Access Compliance Report

Public Rights-of-Way

(Curb Ramps)

Intersection ID: 53831	Main Street: SHARON_RIDGE_LN	Cross Street: SHARON_ACRES_RD	Location: SE
ADA ID: 6CF0DA405739	Ramp Type: BlendTrans1	Initial Pass/Fail: Fail	Overall Compliance: No
		Severity Score: 10

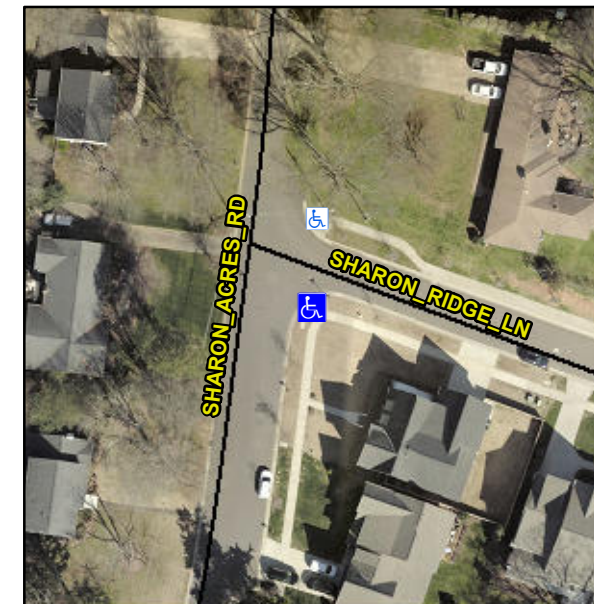
Not Found, R304.5.1, R304.5.3

Compliance	Description	Data	Compliance	Description	Data
N/A	Ramp Length (in)	93.0	Yes	BlendTrans Slope (%)	2.4
No	Ramp Width (in)	47.0	No	BlendTrans XSlope (%)	3.8
N/A	Flare Type LT	N/A	N/A	Flare Type RT	N/A
N/A	Flare Slope LT (%)	N/A	N/A	Flare Slope RT (%)	N/A
N/A	Flare Traversable LT?	N/A	N/A	Flare Traversable RT?	N/A
N/A	Landing Length (in)	N/A	N/A	DWS Provided?	N/A
N/A	Landing Width (in)	N/A	N/A	DWS Contrast?	N/A
N/A	Landing Slope (%)	N/A	N/A	DWS Length (in)	N/A
N/A	Landing X Slope (%)	N/A	N/A	DWS Full Width?	N/A
N/A	Landing Curb? (Y/N)	N/A	N/A	DWS Offset (in)	N/A
N/A	Shared Landing?	N/A			
N/A	Gutter Ponding?	N/A	N/A	Gutter Slope (%)	N/A
N/A	Gutter Lip Ht (in)	1.0	N/A	Gutter X Slope (%)	N/A
N/A	Painted X Walk1?	No	N/A	Painted X Walk2?	No
	X Walk 1 Direction	To N		X Walk 2 Direction	To W
	X Walk 1 Width (in)	N/A		X Walk 2 Width (in)	N/A
	X Walk 1 Slope (%)	5.3		X Walk 2 Slope (%)	3.5
	X Walk 1 X Slope (%)	0.0		X Walk 2 X Slope (%)	6.5

N/A	Ramp inside XWalk1?	N/A	N/A	Ramp inside XWalk2?	N/A
	Road Slope (%)	2.3		Clear Space?	N/A
	Road X Slope (%)	1.9	N/A	Clear Space to XWalk (in)	N/A
N/A	Any Obstructions?	N/A	N/A	Storm Grate/Utility Hazard?	N/A
	Obstruction Type			Storm Grate/Utility Type	
		N/A			N/A
			Yes	Surface Condition? (G/P)	Good
			No	Curb Slope (%)	8.6

Remove & Replace Curb Ramp With Two New Directional Ramps or Equivalent.
